Town of Hillsborough

Addendum #1 for the Lawndale Basin Sewer Rehabilitation and Replacement Project  
Questions and Responses from the Pre-Bid Meeting: 7-11-2023

LAWDALE BASIN SEWER  
REHABILITATION AND REPLACEMENT  
LINED MANHOLE MAP

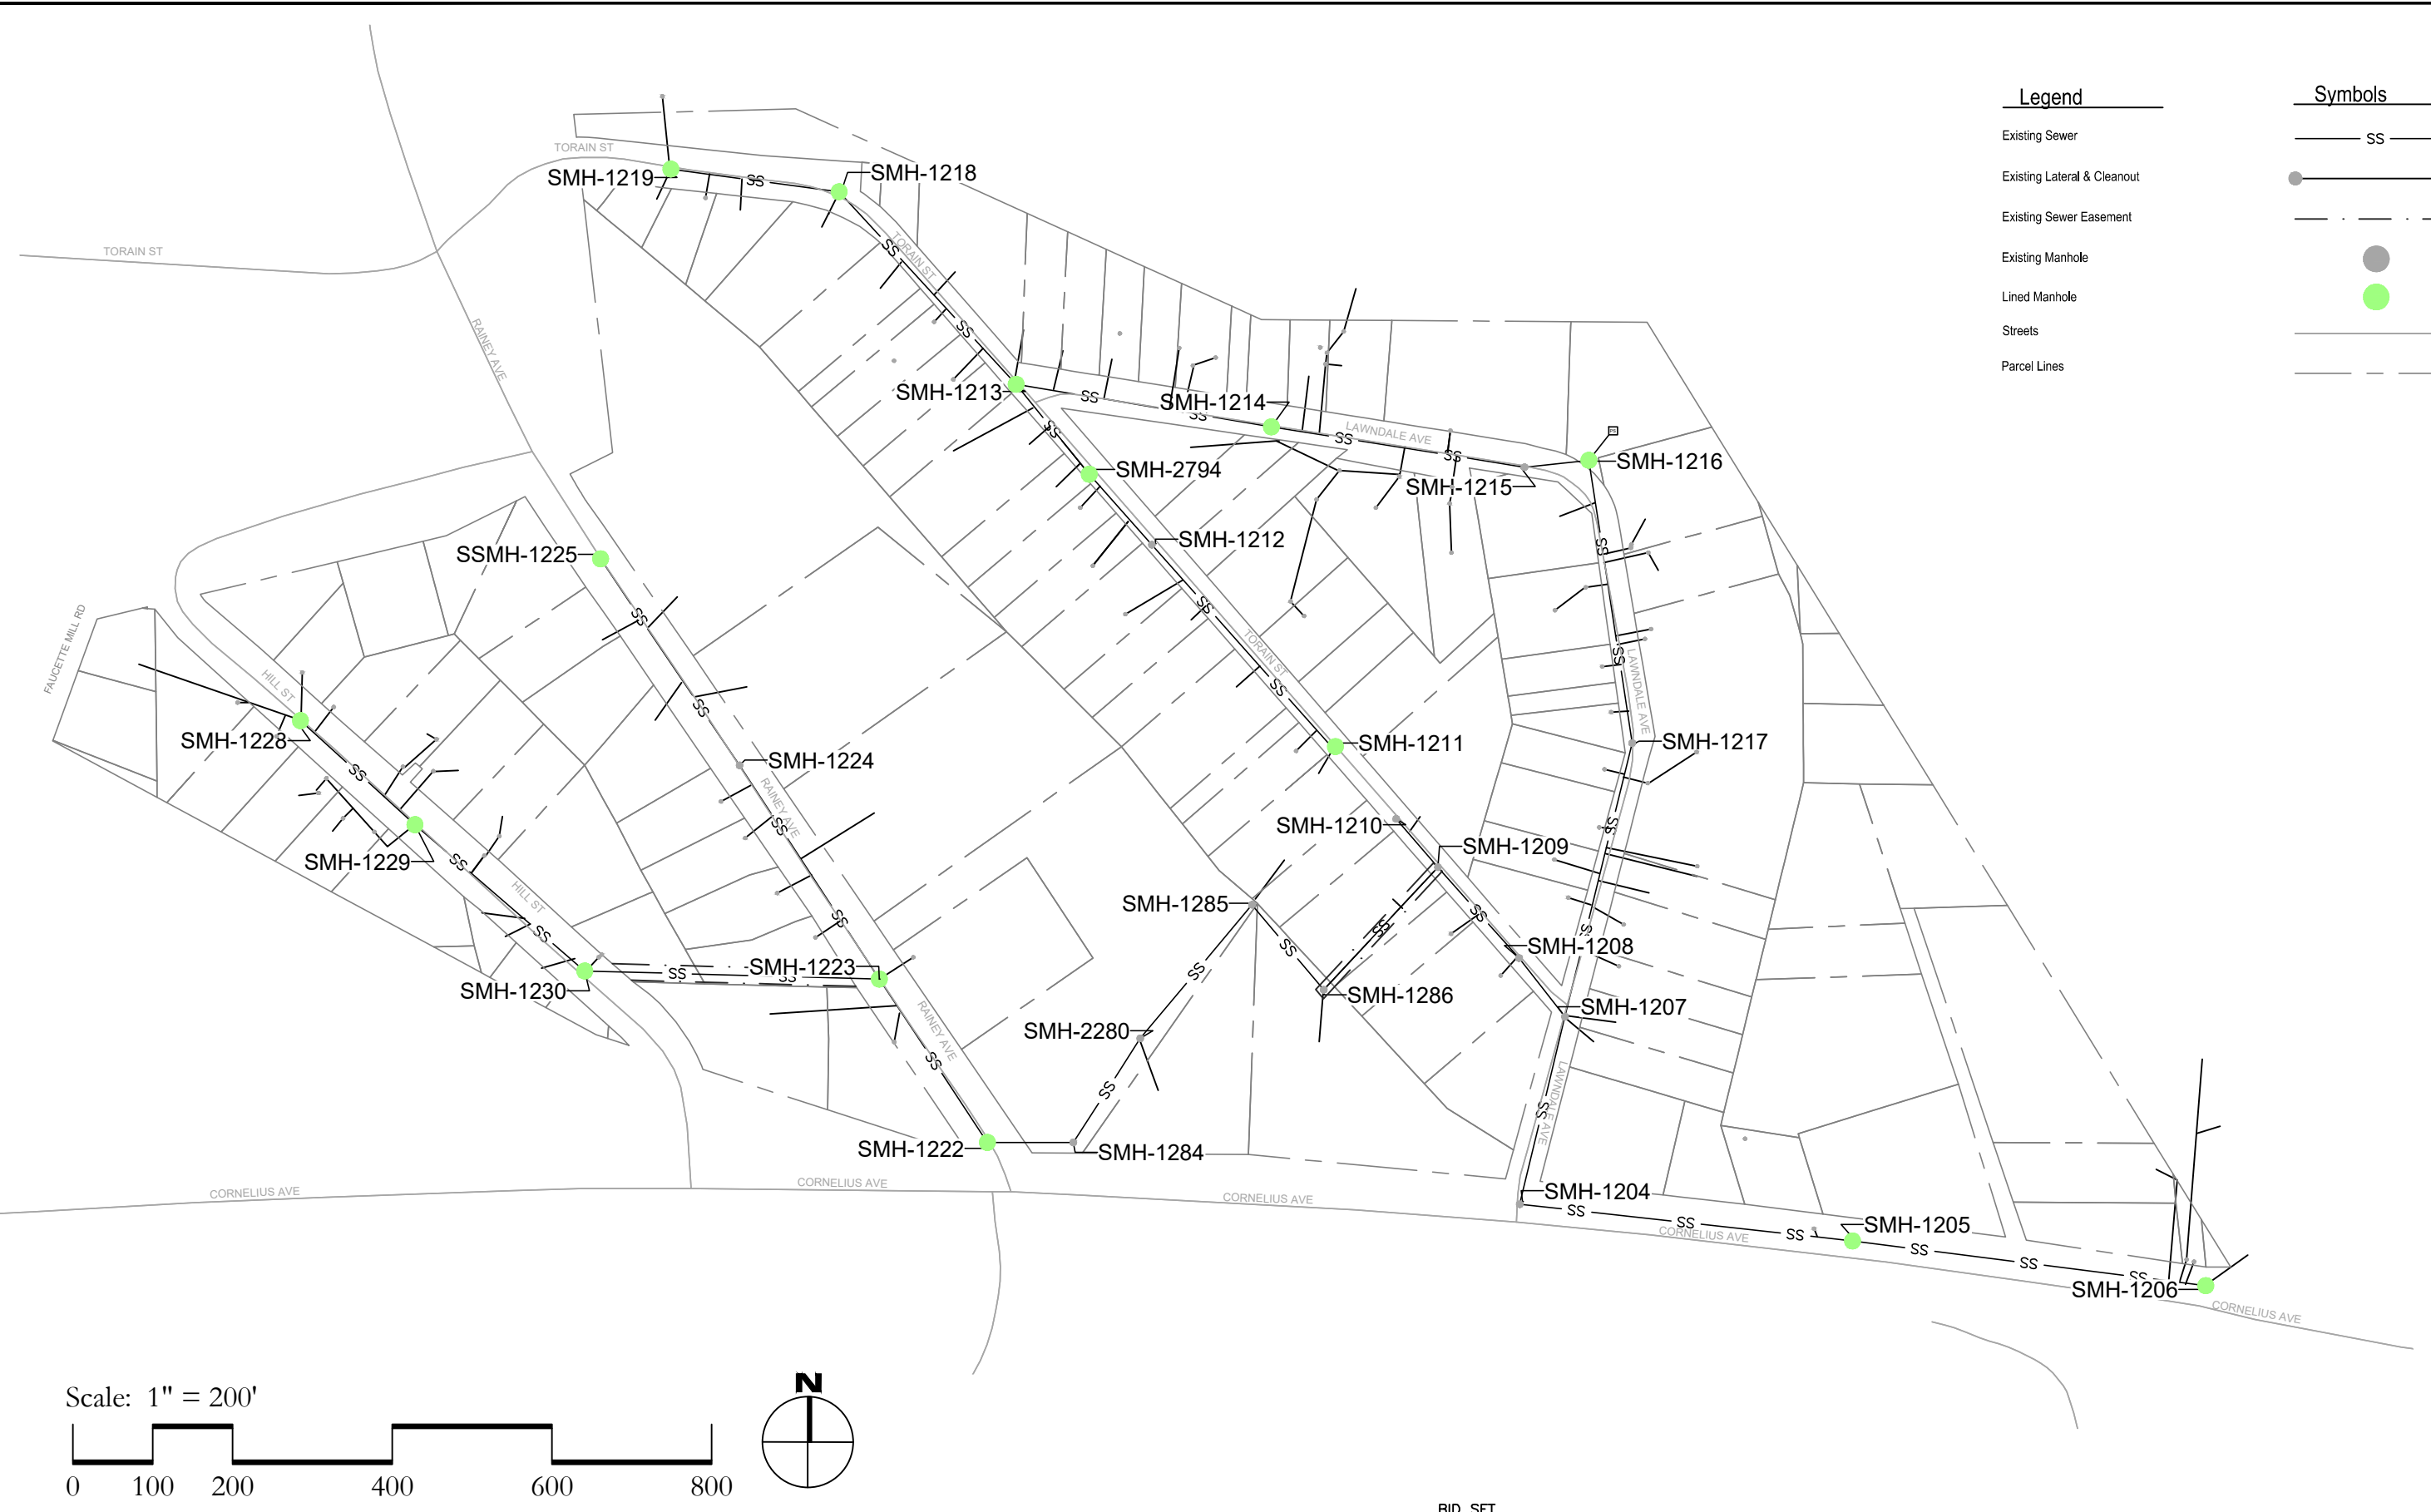
8. Clarification on lined manholes: Contractor to repair any manholes damaged during the project. If a lined manhole is damaged, it must be repaired per lining manufacturer's recommendations (contact TPT Coating). The manholes below are among those that have lining, also see the attached exhibit.

- a. SMH-1219
  - b. SMH-1218
  - c. SMH-1213
  - d. SMH-2794
  - e. SMH-1211
  - f. SMH-1214
  - g. SMH-1216

- h. SMH-1206
  - i. SMH-1205
  - j. SMH-1222
  - k. SMH-1223
  - l. SMH-1225
  - m. SMH-1230
  - n. SMH-1229
  - o. SMH-1228
9. Clarification on warranty period for private property work under the Alternate Bid: The Contractor's plumber must warranty the work on private property directly with the homeowner for one (1) year, this warranty will be referenced in the Right of Entry document.
10. Clarification of locations under Alternate B: Call out added to Sheet C1.3 for laterals to abandon in place.
11. Additional note added to Alternate Bid Notes: Lateral replacements will require some field verification by the contractor. The locations of some laterals will likely be different than drawn.
